Donald L. Welch
Architect

February 24, 2017 (Revised 04-23-2017)

RE: Brighton Recovery Campus
Plan Review Comment Responses
Building 'D'
4925 South 900 East
Salt Lake County, Utah

CODE REVIEW COMMENT RESPONSES:

A2 4A

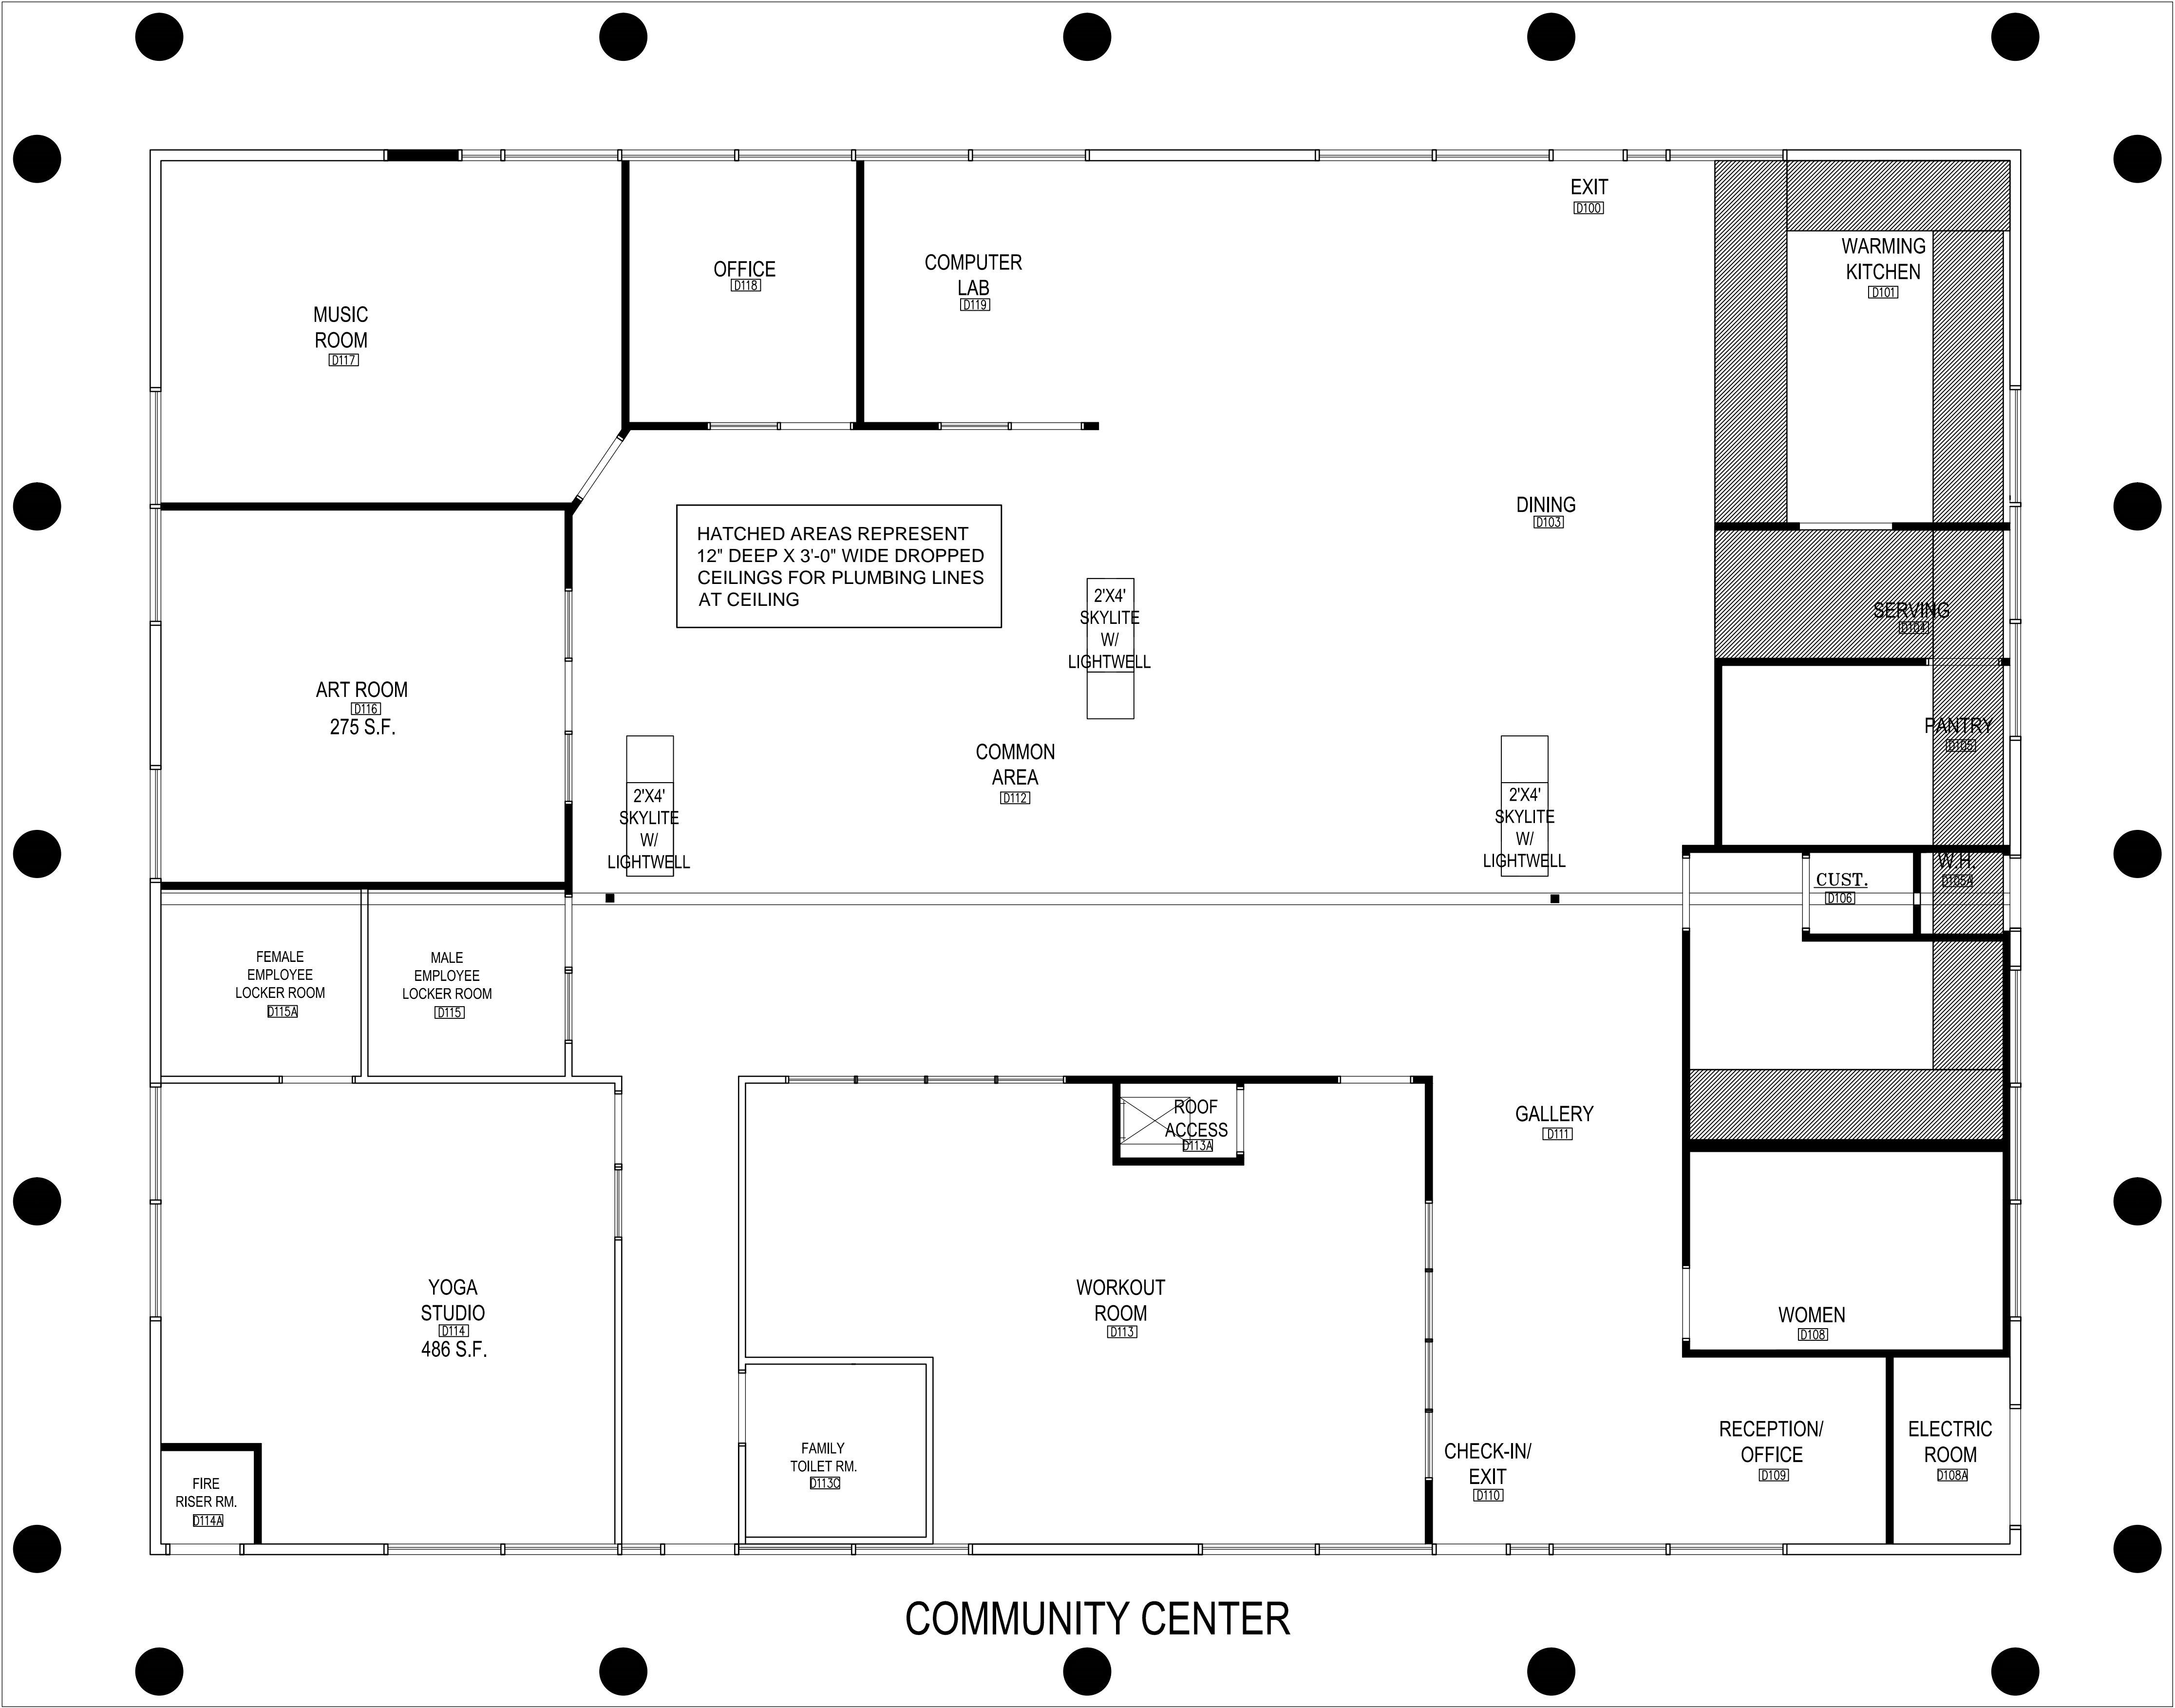
- E. I. Please refer to sheet A2.4 and A2.4A for new corridor showing extra exit from building, meeting egress requirements.
- A4. Sheet A4.2A (should be A2.4A)

- A. Please refer to Sheet A2.4A for accessible seating areas for 5% of the dining surfaces for for seating and standing spaces..
 - B. Please refer to sheet A2.4A and A8.2 for dimensions of the accessible toilet compartments and toilet compartment swinging doors.

- C. Please refer to sheet A2.4A and A4.3 for clear floor space in front of lavatories and urinals.
 - D. Please refer to sheet A2.4A and A4.3, for Reception counter clearance information.

- E. Please refer to sheet A2.4A for clearances around workout equipment.
 - F. Please refer to Locker room notes on sheet A2.4A for employee locker room turning space, 5% of lockers are accessible in each locker room, clear floor space in front of accessible lockers, accessible reach ranges of lockers (sheet A8.2), operable parts for lockers are accessible. Also for Bench requirement notes for clear floor space for parallel approach, dimensions, back support, and structural strength of benches.

- G. Please refer to sheet A2.4A for for adequate maneuvering clearance for doors D105 and D117.
 - H. Please refer to sheet A2.4, A2.4A, and A4.3 for family/assisted-use restroom.

- I. Please refer to Sheet A2.4A for clear floor spaces for forward approach for each type of gaming table provided.
- A5. Sheet A4.3: Please refer to Sheet A4.3, for Revised detail A, and deleted details B and C.

COUNTER/BAR DETAIL
SCALE: -- = 1'-0"

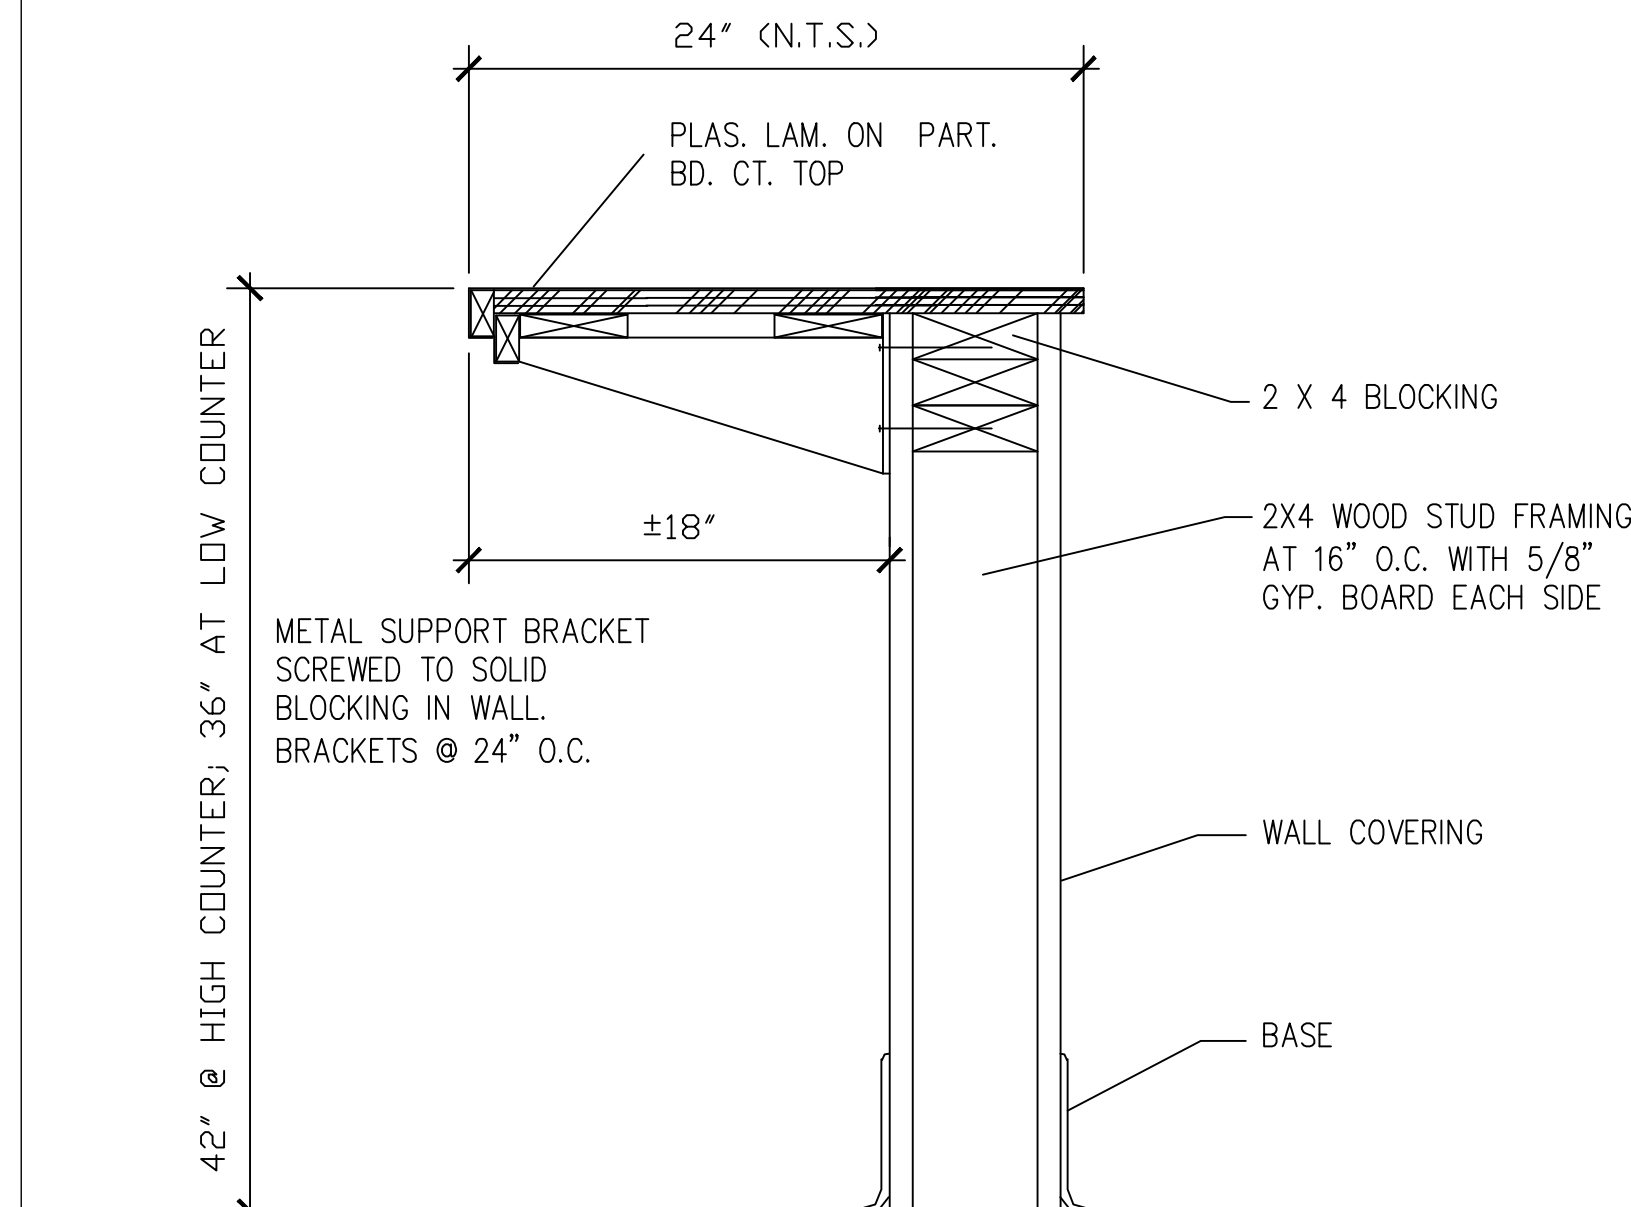
- B. Please refer to Sheet A2.4A and Detail A/A4.6 for counter/bar detail.
 - C. I. Please refer to Sheet A2.4A for location of Tactile Exit signs at all exit doors, Also, please refer to Electrical Sheets for Exit signage.

MP1D

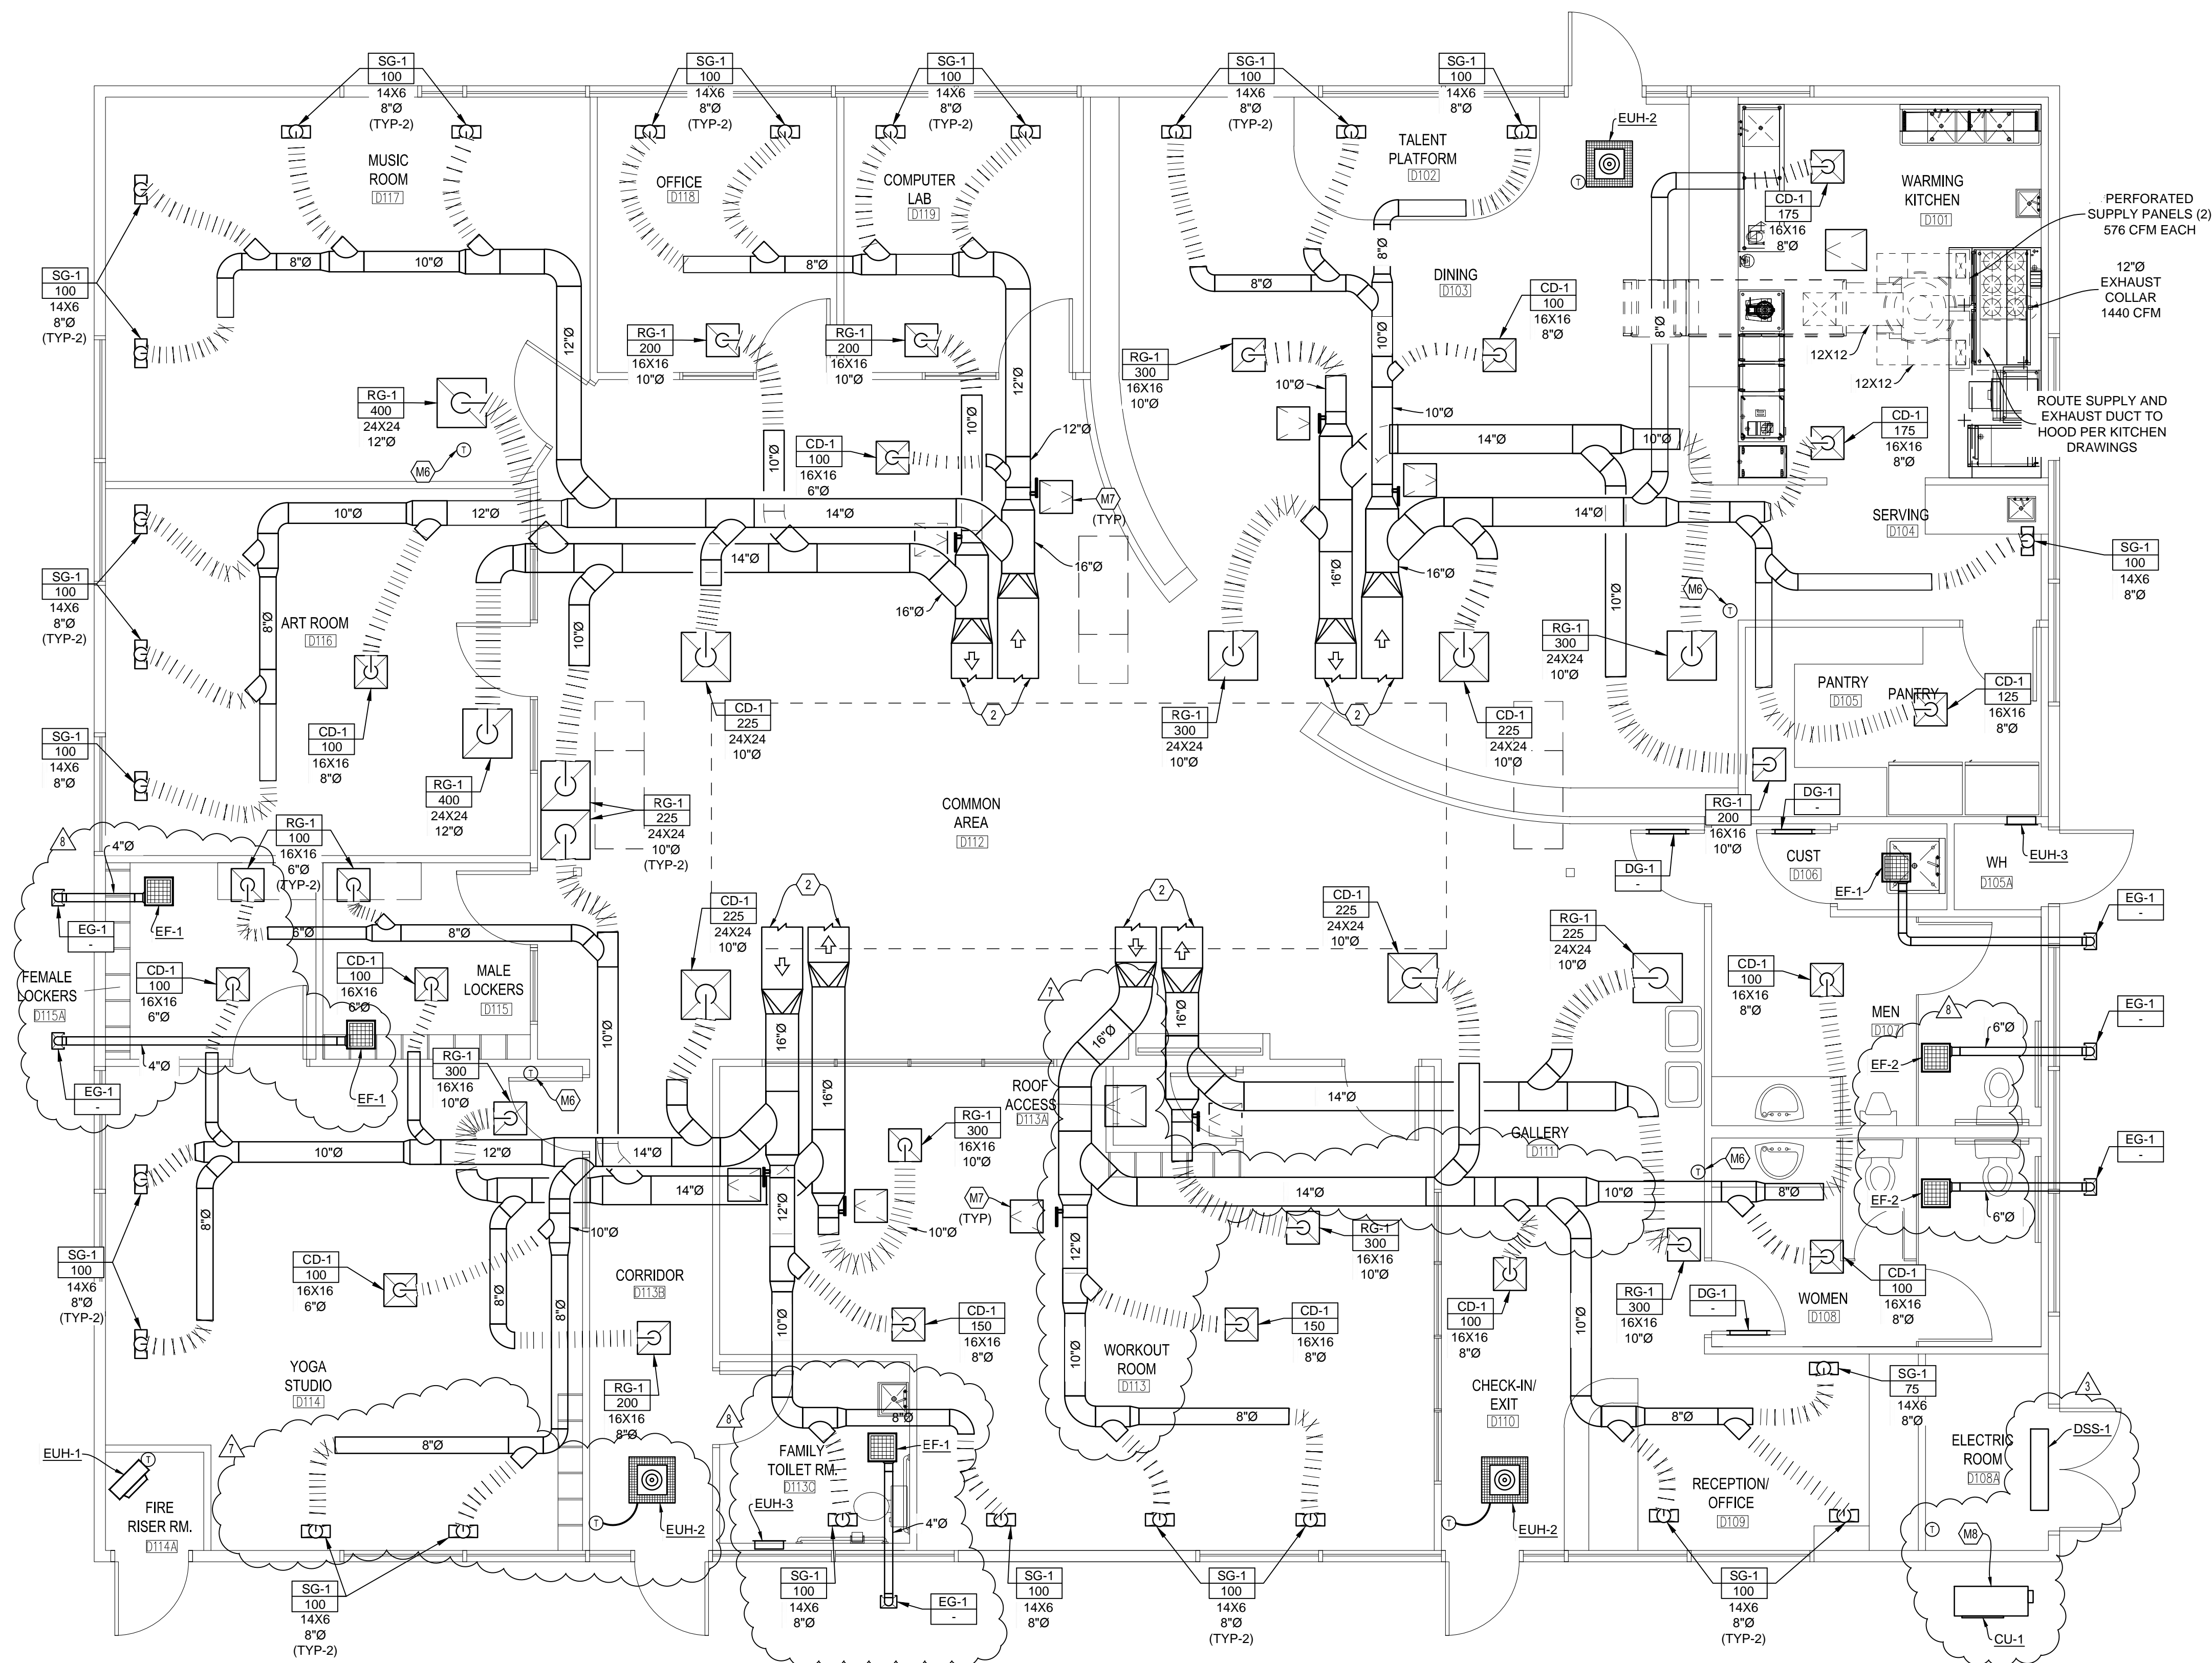
M1. Sheet MP1C: Please address the following:

Response: See updated sheet MP1D. Manufacturer's recommended service clearance boundaries are indicated at each RTU. The RTUs are to reside in similar locations of replaced RTUs within the equipment well.

Response: See updated sheet MP1D. A 10 foot offset from all RTU fresh air intakes is identified to clarify the intent.
